Subject: Revision 10a of the Inservice Testing Program for Pumps and  
Revision 13a of the Inservice Testing Program for Valves  
Byron Nuclear Power Station, Units 1 and 2  
Facility Operating Licenses NPF-37 and NPF-66  
NRC Docket Nos. 50-454 and 50-455

Revision 10a of the Byron IST Pump Program is provided in Enclosure 1. Attachment A provides a summary of all of the changes associated with this revision. The two major changes are discussed below.

Revision 13a of the Byron IST Valve Program is provided in Enclosure 2. Attachment B provides a summary of all of the changes associated with this revision. The major changes are discussed below.

**Revision 10a of the Inservice Testing Program  
Plan for Pumps**

FIGURE 2

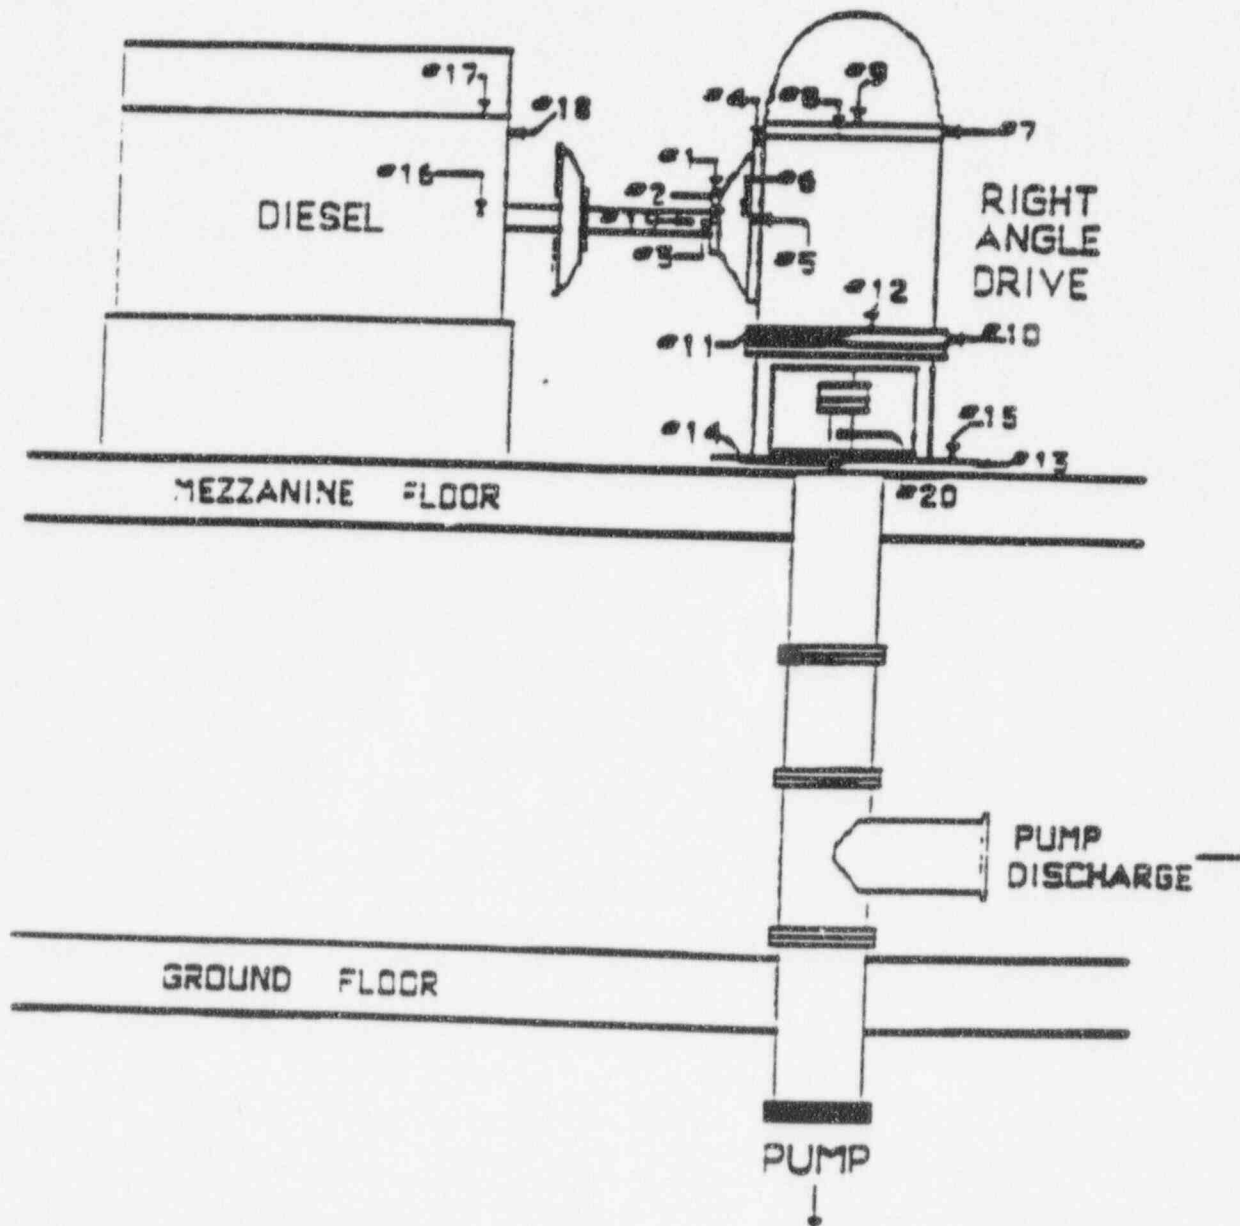
The Essential Service Water Makeup Pumps OSX02PA & B are of a very unique design (see Fig. 1 and Fig. 2). The pump is attached to a horizontal diesel driver via a right angle gear drive, and the gear drive is located approximately 39 feet above the pump. This configuration assures pump operability during the design basis flooding of the Rock River.

The Essential Service Water Makeup Pumps OSX02PA & B are classified as centrifugal pumps. ANSI/ASME OMa-1988 Part 6 Paragraph 4.6.4 (a) requires that for centrifugal pumps, vibration measurements are to be taken in two directions on each accessible pump bearing housing and in the axial direction on each accessible pump thrust bearing housing. The OM Code does not require vibration monitoring of the gear drive. For the Essential Service Water Makeup Pumps, however, the pump thrust bearings are physically located within the gearbox which houses the gear drive. This pump configuration is not addressed by OM Part 6. With this unique configuration, the only means of collecting vibration readings for the pump thrust bearing is to physically take the vibration measurements on the gear box itself. The limitations of taking the vibration readings at this location is that the resultant vibration readings are not solely attributable to the pump thrust bearing. The vibration readings obtained are the result of other factors such as the vibration induced by the gear drive itself.

When recording vibration results based on a frequency response range to 2000 Hz., which has been the customary practice at Byron for these pumps, the gear drive significantly contributes to the vibration which is measured at the gearbox location. The vibration induced by the gear drive is largely due to the gears meshing. Taking into account the pump running speed and the number of gear teeth, Byron has calculated the gear mesh frequency and hence a vibration frequency attributable to the gear drive. This frequency was calculated to be 1080 Hz. By performing spectral analysis of the vibration data obtained at the gearbox locations, engineering personnel were able to identify the vibration which was attributable to the gear drive, as there was an easily identifiable peak within this 1080 Hz frequency range. This particular peak, associated with the gear mesh frequency, exceeded the acceptance criteria of Table 3a of OM Part 6. The OM Part 6 Table 3a

acceptance criteria applies to pump bearings and pump thrust bearings, and not to gear drives which induce vibration due to the gears meshing. Additionally, Paragraph 4.6.1.6 of OM Part 6 states that the frequency response range of the vibration measuring transducers and their readout system shall be to at least 1000 Hz. The 1080 Hz gear mesh frequency goes beyond what is required for the frequency response range of the vibration measuring transducers and their readout system. As a result, for the gearbox locations on these pumps, Byron will apply the OM Part 6 Table 3a acceptance limits in the frequency range of one third minimum pump shaft rotational speed up to and including 1000 Hz, and will not apply the OM Part 6 acceptance limits to the gear drive frequencies above 1000 Hz. By applying a cutoff at 1000 Hz, the resulting peak reading is more applicable to the vibration from the pump thrust bearing. The 1000 Hz cutoff meets the requirements of OM Part 6 for frequency response range of the vibration measuring transducers and their readout system. Additionally, vibration measurements will continue to be taken at the lowest accessible bushing on the pump shaft. These vibration readings will be subject to the OM Part 6 Table 3a acceptance criteria.

Both the A and B pumps have experienced vibration at the gearbox location in the vicinity of 0.4 - 0.45 in/sec since installation, at which time they were verified by the vendor to be operating properly. They have continued to display such vibration levels throughout their service life. In August of 1992, the gearbox for pump OSX02PA was replaced. The replacement was performed due to repair work which was performed on the pump and was not attributable to a gearbox problem. It was felt that this was an opportunity to discover if a rebuilt gearbox would reduce the vibration levels. Replacement with a rebuilt gearbox did not significantly reduce vibration levels at the gearbox location. Additionally, an inspection of the original gearbox revealed that it was in an acceptable condition. Also, in 1995 the OSX02PA gearbox was opened and visually inspected. It should be noted that the OSX02PA pump has experienced slightly higher vibration levels at the gearbox location than the OSX02PB pump. The gearbox of the OSX02PA pump was found to be in excellent condition. ComEd's conclusions are that the vibration levels recorded at the gearbox locations do not have a detrimental affect on the gearbox or the pump, and that this vibration level is normal for such a pump configuration. Although the OM Code vibration limits will not be applied to the vibration levels attributed to the gear mesh frequencies, Byron will continue to monitor these vibration levels, and take action as appropriate.
